Well Name: JICARILLA A	Well Location: T23N / R2W / SEC 1 / NESW /	County or Parish/State: RIO ARRIBA / NM
Well Number: 3	Type of Well: CONVENTIONAL GAS WELL	Allottee or Tribe Name: JICARILLA APACHE
Lease Number: JIC156	Unit or CA Name:	Unit or CA Number:
US Well Number: 3003982312	Well Status: Producing Gas Well	Operator: DJR OPERATING LLC

Notice of Intent

Type of Submission: Notice of Intent	Type of Action: Plug and Abandonment
Date Sundry Submitted: 05/24/2022	Time Sundry Submitted: 01:17
Date proposed operation will begin: 05/24/2022

Attachment to notice of Intention to Abandon

Proposed Wellbore Diagram
DJR Operating, LLC
Jicarilla A 156 3
API # 30-039-82312
NE/SW, Unit K, Sec 1, T23N, R2W
Rio Arriba County, New Mexico

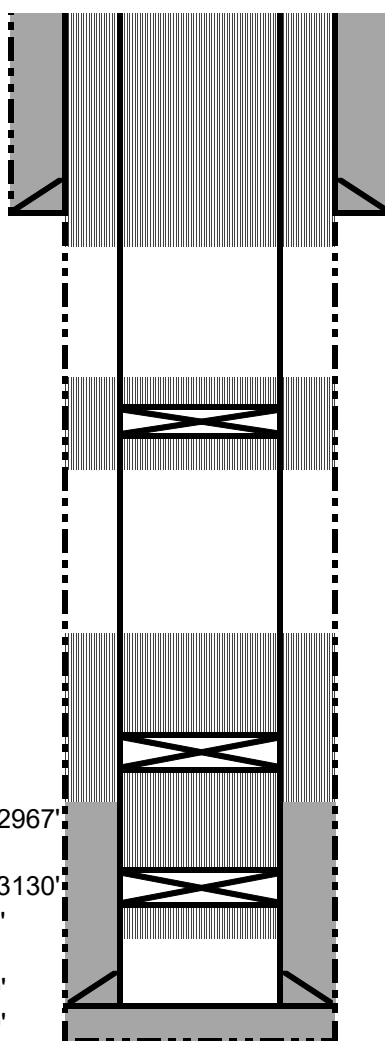
1. Plugging operations authorized are subject to the attached "General Requirements for Permanent Abandonment of Wells on Federal and Indian Lease."
2. The following modifications to your plugging program are to be made:
 - a) Extend Plug 2 from perfs at 3106' to a TOC of 2518' to account for the BLM Kirtland top and required excess.
 - b) Extend the Plug 3 TOC to 1594' to account for required excess.
3. Farmington Office is to be notified at least 24 hours before the plugging operations commence (505) 564-7750.

Extend Plug 2 from perfs at 3106' to a TOC of 2518' to account for the BLM Kirtland top and required excess.

Extend the Plug 3 TOC to 1594' to account for required excess.
